CITY OF ALBUQUERQUE

**Re: Garcia Residence – Lot 11 Black Farms
Grading and Drainage Plan with Engineer's Stamp Dated 11-17-14
(C13D027B)**

<p>ENGINEER'S SEAL</p>	<p>LOT 11 BLACK FARM ESTATES</p>	<p>DRAWN BY WCWJ</p>
	<p>GRADING AND DRAINAGE PLAN</p>	<p>DATE 11-17-14</p>
<p>11/17/14</p>		<p>21420-LAYOUT-11-17-14</p>
<p>DAVID SOULE P.E. #14522</p>	<p><i>Rio Grande Engineering</i></p> <p>1606 CENTRAL AVENUE SE SUITE 201 ALBUQUERQUE, NM 87106 (505) 872-0989</p>	<p>SHEET # —</p>
		<p>JOB # 21420</p>

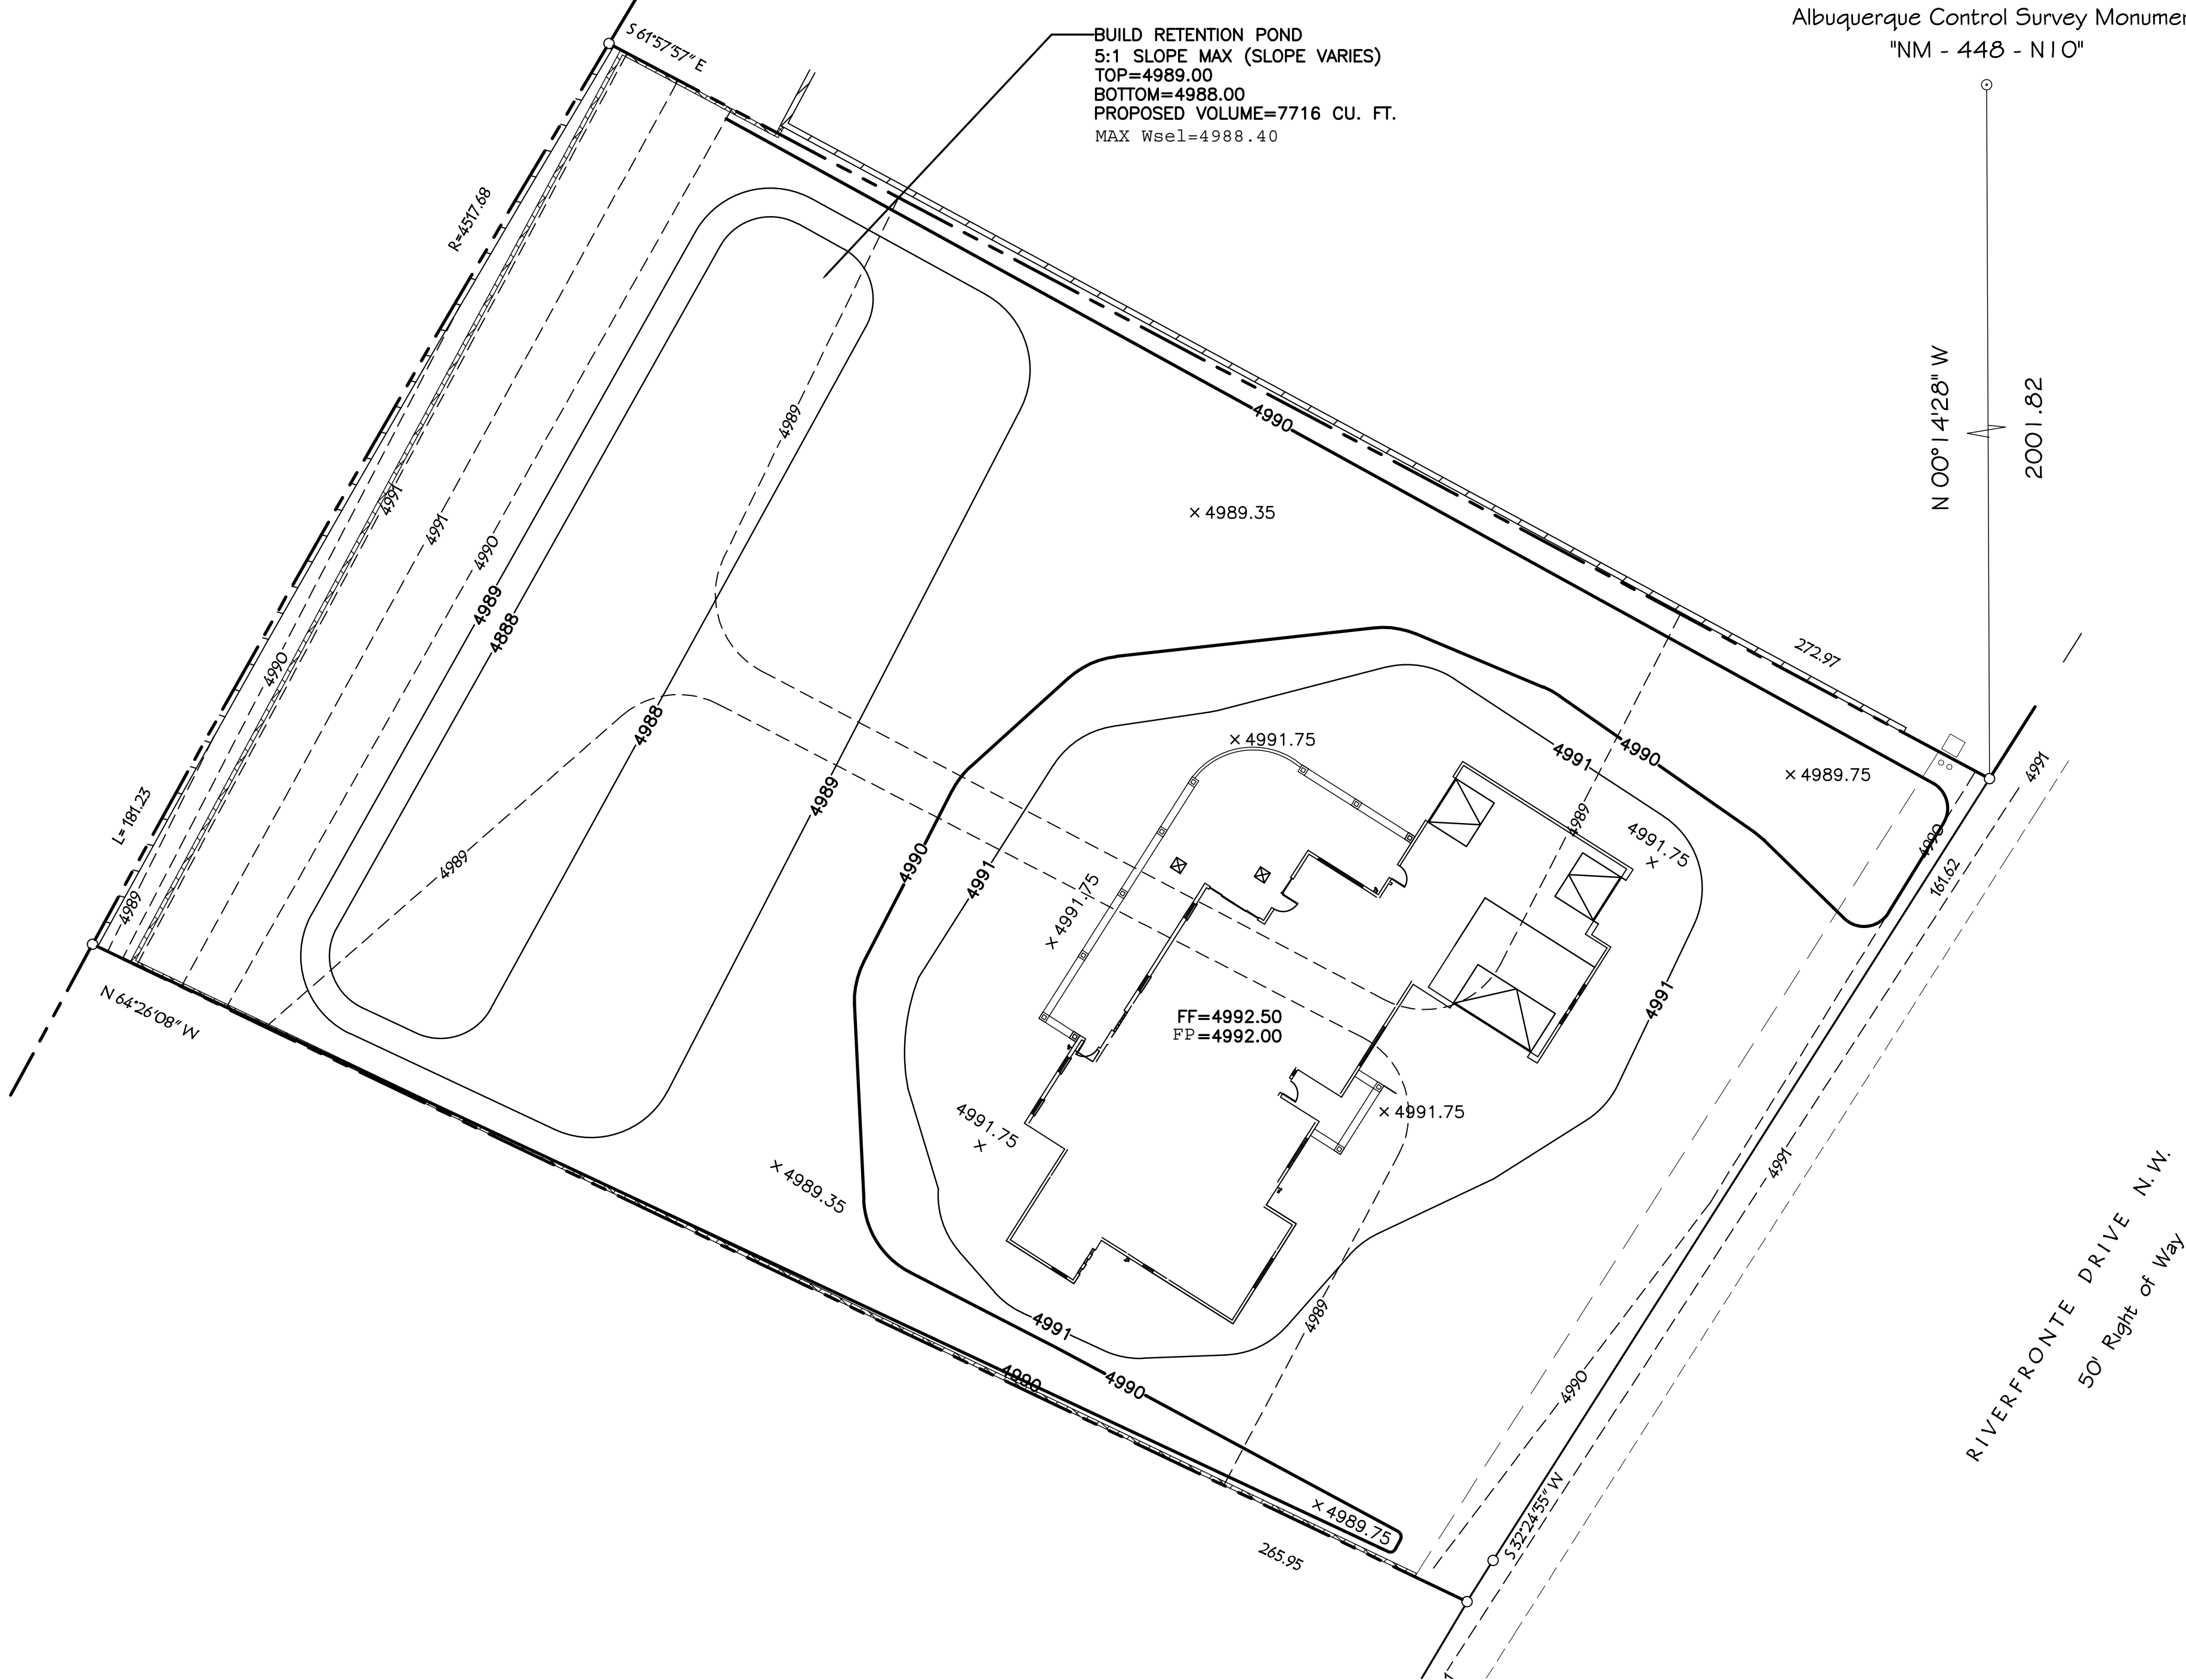
Based upon the information provided in your submittal received November 17, 2014, the above referenced plan is approved for Building Permit. Please attach a copy of this approved plan to the construction sets prior to sign-off by Hydrology.

For future submittals, refer to water harvesting as First Flush. Calculate the First Flush as follows. Per the City Drainage ordinance, the 90th Percentile Storm Event, which is 44 inches, is to be managed. Reduce 0.44 inch by the 0.1 inch for the initial impervious abstraction in Table A-6 of Section 22 of the DPM. Multiply the remaining 0.34 inch by your impervious area. This is the amount of the First Flush necessary for the site.

Prior to Certificate of Occupancy release, Engineer Certification per the DPM checklist will be required.
